Access Compliance Report

Public Rights-of-Way

(Curb Ramps)

Main Street: KELLOGG_DR Cross Street: YORBA_LINDA_BLVD Location: SE

ADA ID: RPAT220223091312 Ramp Type: Type 3 - Combination 1 Initial Pass/Fail: Fail Overall Compliance: No Severity Score: 2

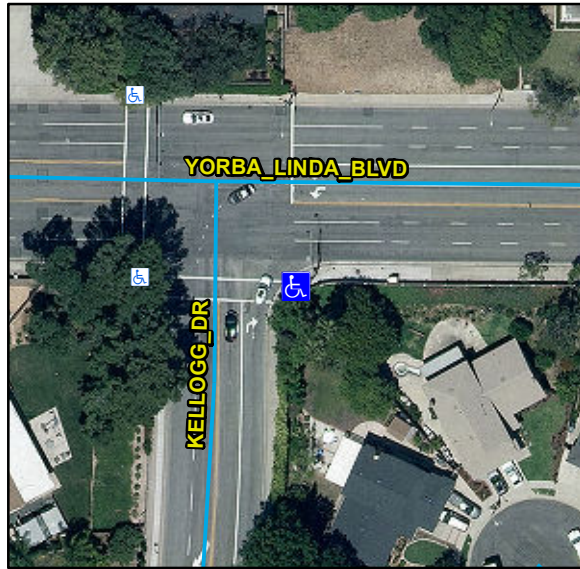
R304.2.2, R304.5.3, STD 1115

Remove & Replace Entire Ramp.
